AREVA REPORT NO. ANP-3286NP, Revision 0

RESPONSES TO RAI FROM SRXB ON MNGP TRANSITION TO AREVA FUEL

ANP-3286NP
Revision 0

Responses to RAI from SRXB on
MNGP Transition to AREVA Fuel

Figure 1 Key Parameters for Monticello Cycle 28 PRFO 60P/44F

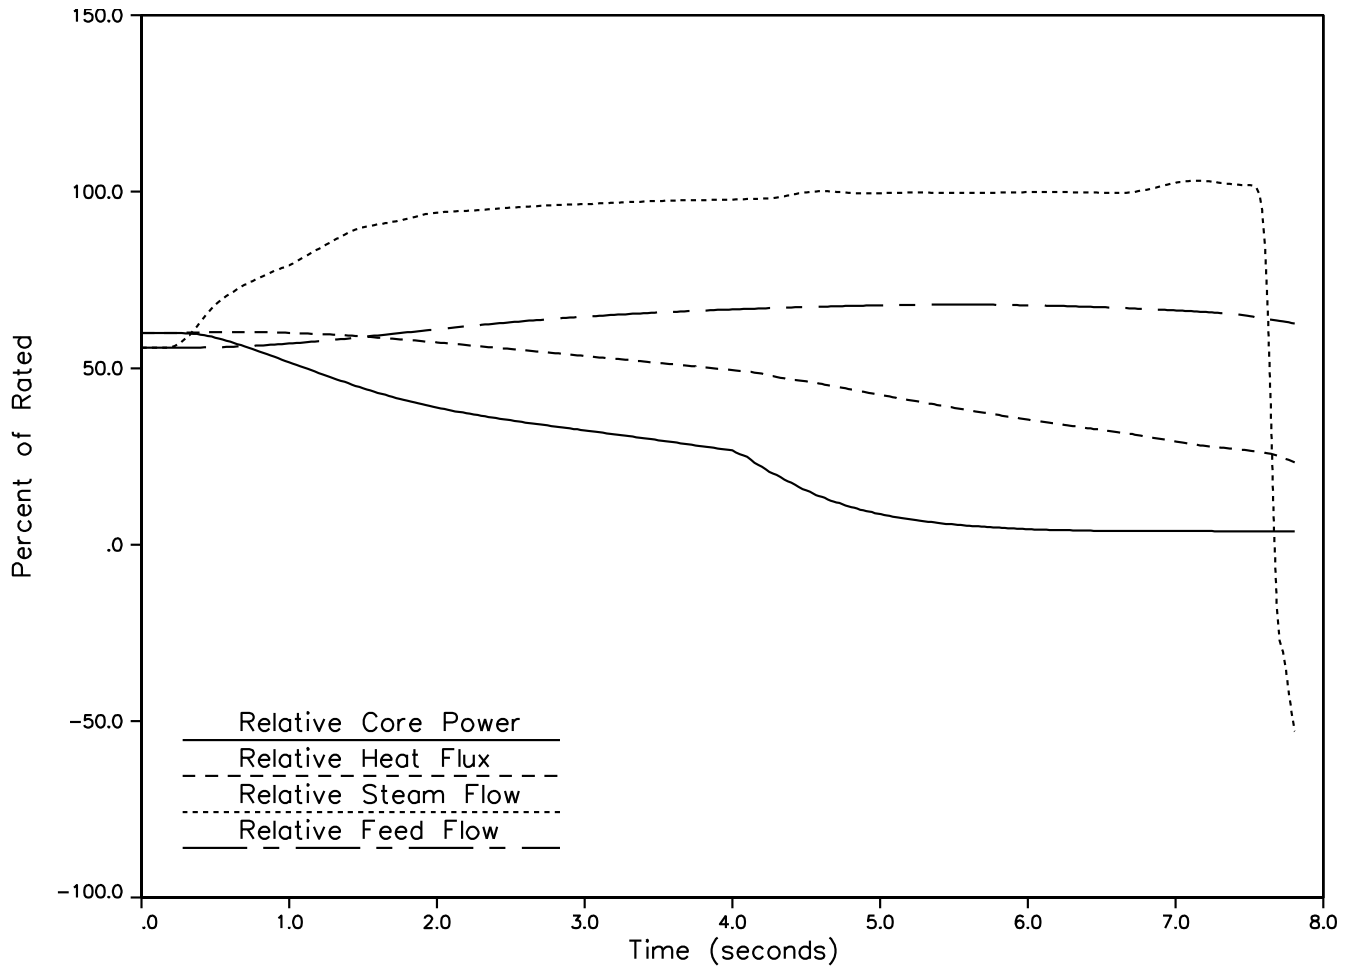
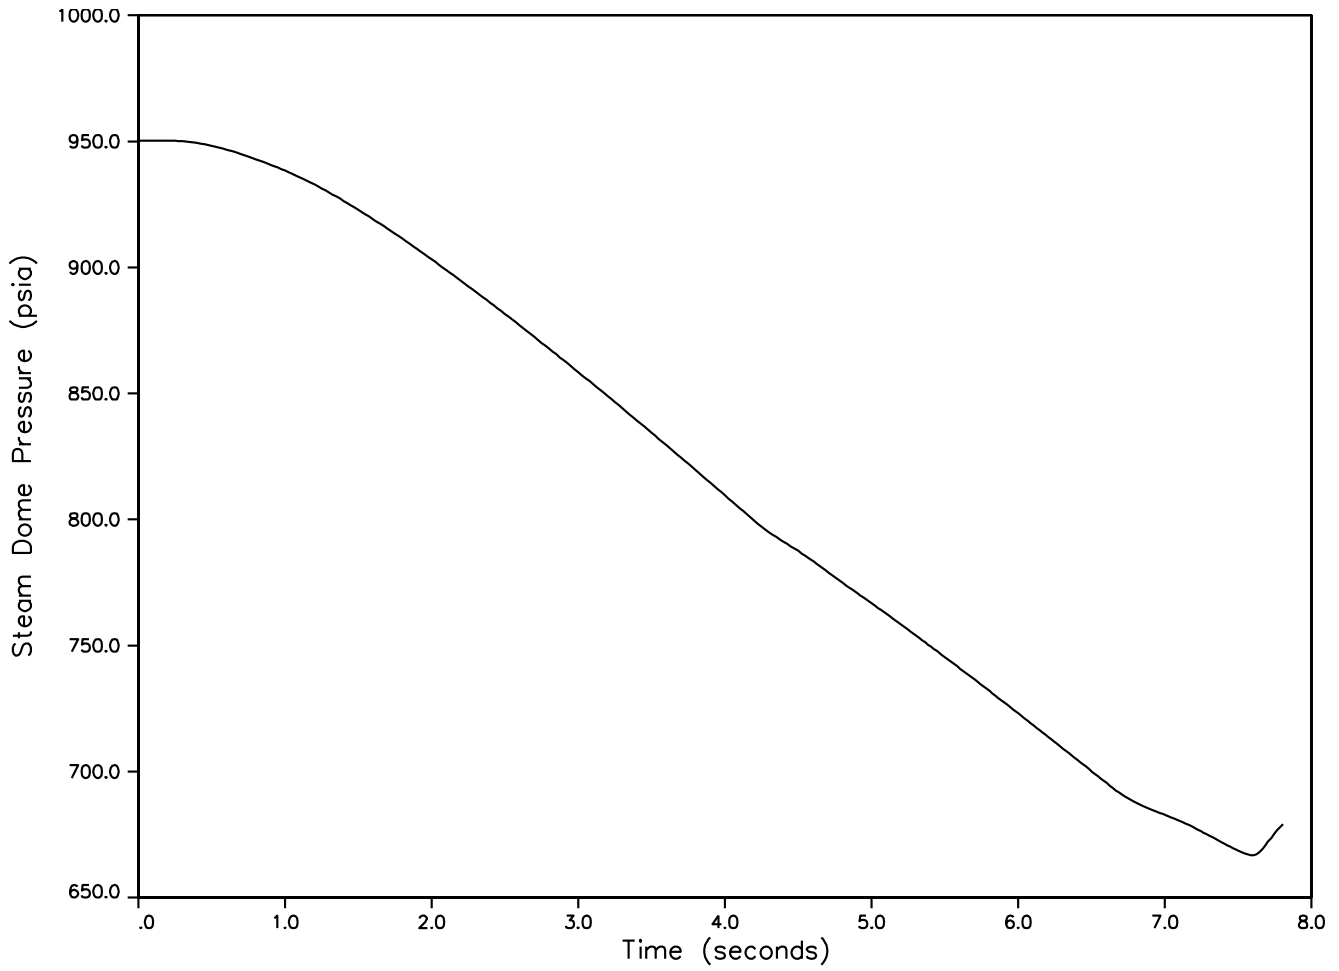
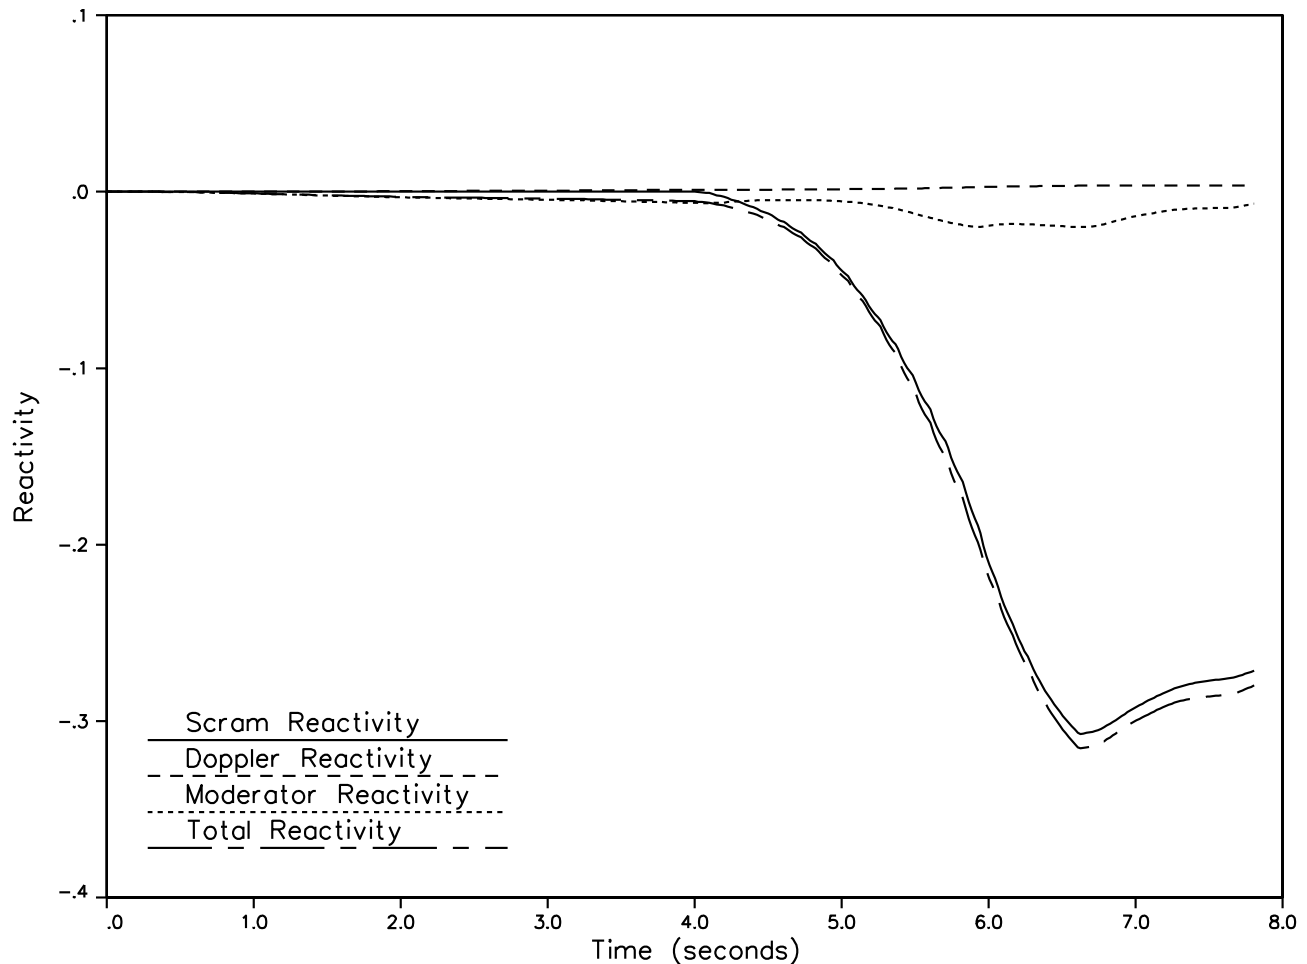
- 10.b) *Identify the statepoint for the limiting event, and for that event, provide plots of reactivity, core power, system pressure, and heat flux.*

The limiting state point was identified to be 60% of rated power and 44% of rated core flow when the event is initiated from early exposures in the cycle.

The requested plots are provided below.

Notice that both the core power and the heat flux are decreasing throughout the depressurization event. The margin to thermal limits increases throughout the PRFO event.
